TRIFECTA DEVELOPMENT SUBDIVISION

Engineering Comments: FINAL PLAT COMMENTS (should be addressed prior to submitting the FINAL PLAT for review and/or signature by the City Engineer):

APPLICATION NUMBER 2 DATE June 15, 2017

DETAIL SITE PLAN

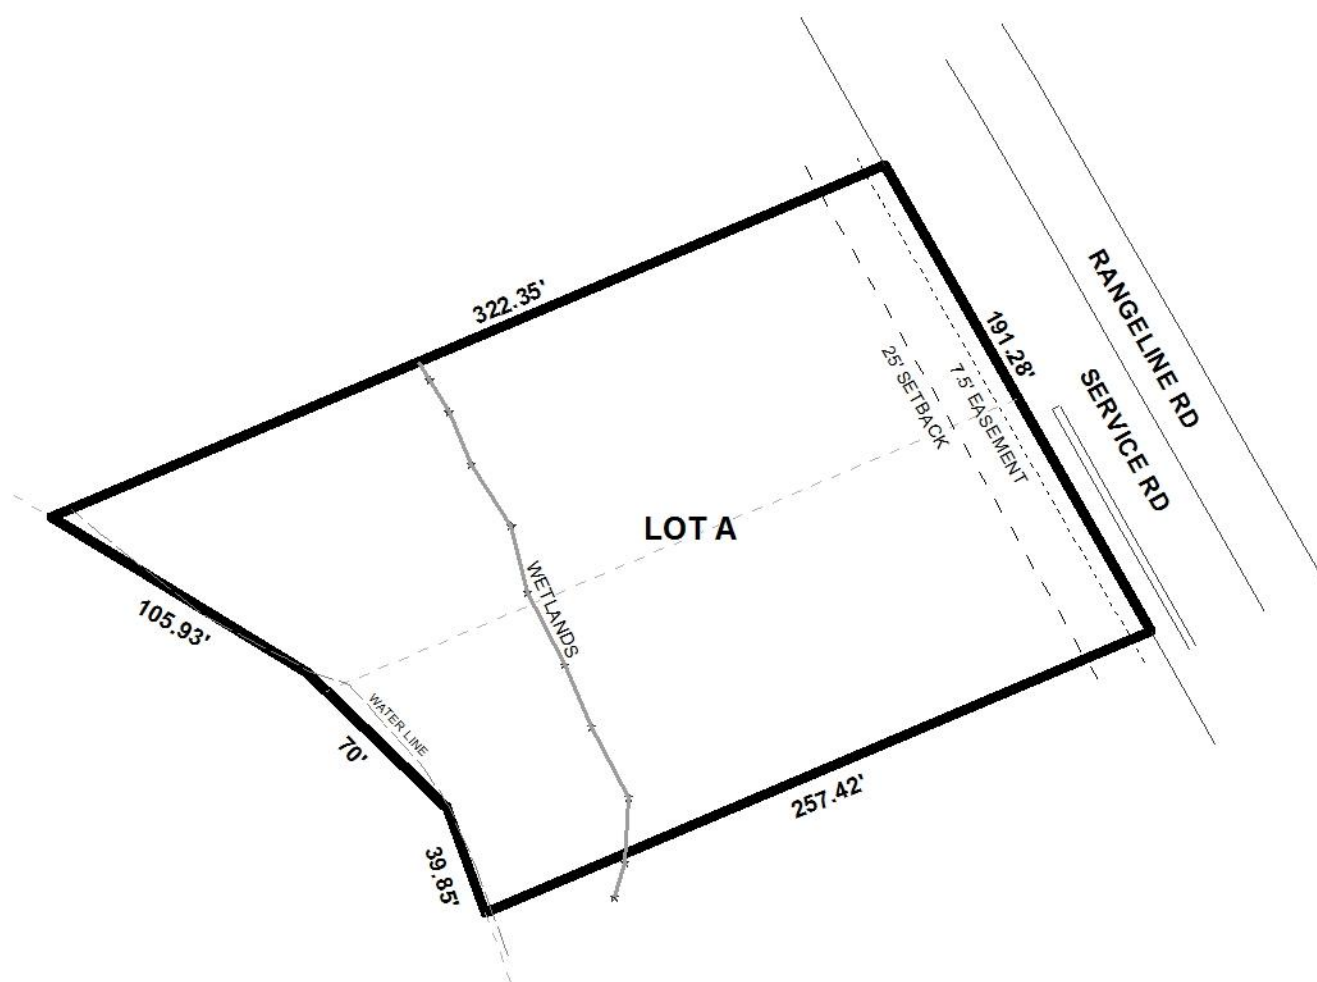
The subject lot has frontage on Rangeline Road Service Road, part of Rangeline Road, an ALDOT facility. According the Future Land Use Map and Major Street Plan, Rangeline Road is considered to be a principal arterial street, without curb and gutter, that requires a 300-foot wide right-of-way width, inclusive of the service roads. The preliminary plat illustrates the right-of-

way distance as “Varies (approx. 400’)” along Rangeline Road. The Final Plat, if approved, should be revised to indicate the minimum existing right-of-way width.

The 25-foot minimum building setback line is depicted on the preliminary plat along Rangeline Road Service Road, and as such, should be retained on the Final Plat, if approved.

There is a 7.5’ drainage and utility easement depicted along the Western perimeter of the proposed Lot A. If approved, a note should be provided on the Final Plat stating that no structures are to be erected within any easement.

The proposed lot exceeds the 7,200 square foot minimum lot size requirement for lots served by public water and sanitary sewer systems; and the lot size information is indicated in both square feet and in acres. If approved, the lot size information should be retained in both square feet and in acres on the Final Plat.

As a means of access management, a note should be placed on the Final Plat stating that Lot A is limited to one curb cut to Rangeline Road Service Road, with any changes in the size, location and design to be approved by Traffic Engineering (and ALDOT, if necessary) and conform to AASHTO standards.

- 1) Revision of the right-of-way width along Rangeline Road Service Road to label the minimum existing right-of-way width;
- 2) Retention of the 25-foot minimum setback line along Rangeline Road Service Road;

- 3) Retention of the 7.5’ drainage and utility easement;
- 4) Placement of a note stating that no structures are to be erected within any easement;
- 5) Retention of the lot size information in both square feet and in acres;

- 6) Placement of a note on the Final Plat stating that Lot A is limited to one curb cut to Rangeline Road Service Road, with any changes in the size, location and design to be approved by Traffic Engineering and ALDOT, and conform to AASHTO standards;
